Service Bulletin

Bulletin No.: PIC5836A

Subject: Rattle Or Buzz Noise From Rear Speaker Or Speakers Worse With High Bass Levels

Models: 2013 Cadillac ATS

3627512

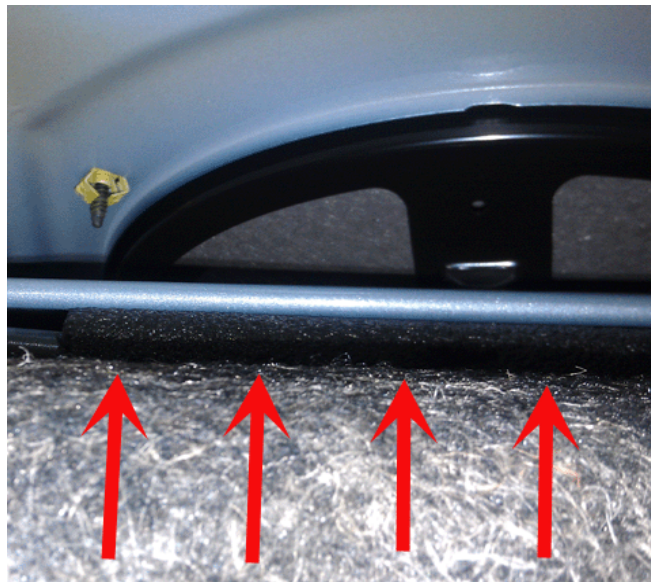
1. Inspect the rear speaker and the surrounding interior trim for proper and secure mounting. If the speaker trim has come loose, replace the speaker. If surrounding interior trim is found to be loose or improperly secured, correctly secure the item and add foam to insulate items as needed. Add foam to the subwoofer speaker connector to prevent contact to the under shelf trim from making contact. Use 1/2" by 5/16" of Kent Adhesive Backed Shim Stock (foam) P/N P40125 or equivalent.

3627504

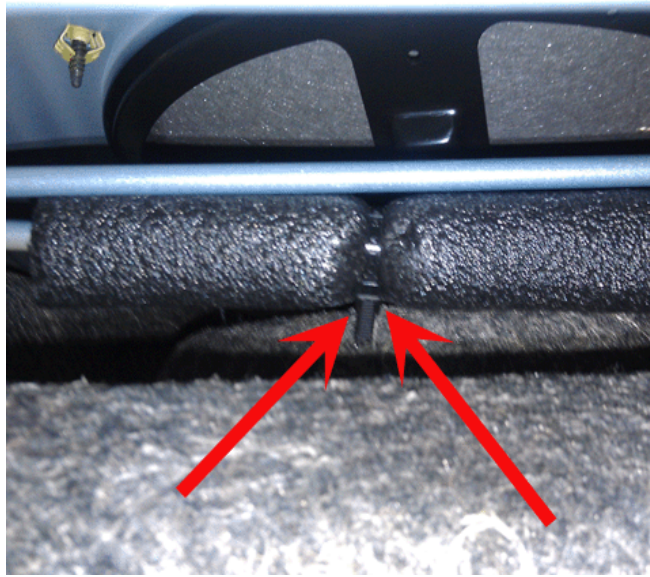
3. Seat belt retractor buzz - Ensure the existing foam torsion spring cover is centered on the deck lid torque rods. Use a zip tie to secure. Add a piece of 3/8" rubber hose (fuel line) to the center belt rear mounting bolt. See pictures below. Note hose on the seat belt bolt (left side) behind torsion spring.

3630391

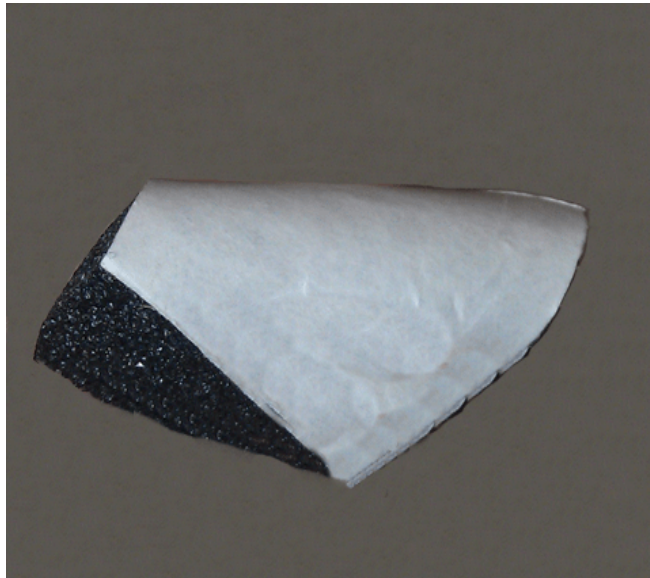
4. Add felt onto the package shelf trim opening to prevent movement between the trim and the child seat tether cover if the felt is not present. Use Kent Adhesive Backed Flocking Tape P/N KT13295 or equivalent. See pictures below.

3627502

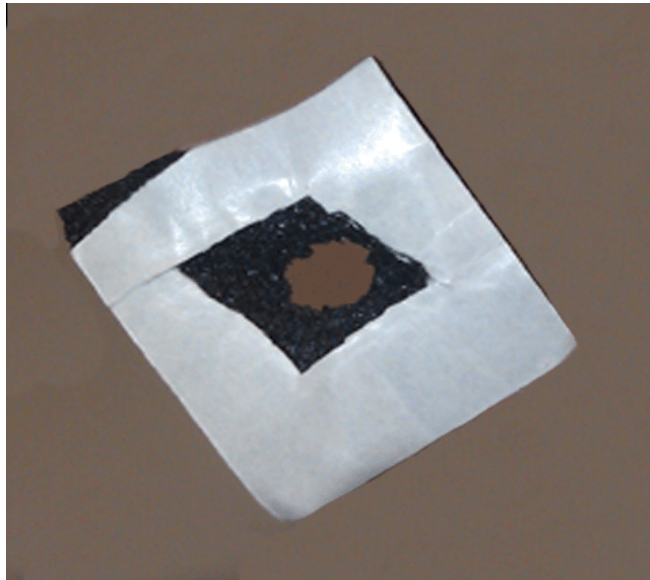
5. Add foam grommets onto each of the Christmas tree fasteners (if not present) prior to reinstalling back into the package shelf sheet metal holes. Use 1" X 1" block of Kent Adhesive Backed Shim Stock P/N P46510 or equivalent to create a foam washer(s) as needed. Fold the 1" x1" block over from corner to corner and carefully cut a hole in the center of the block to create a washer/spacer. See pictures below.
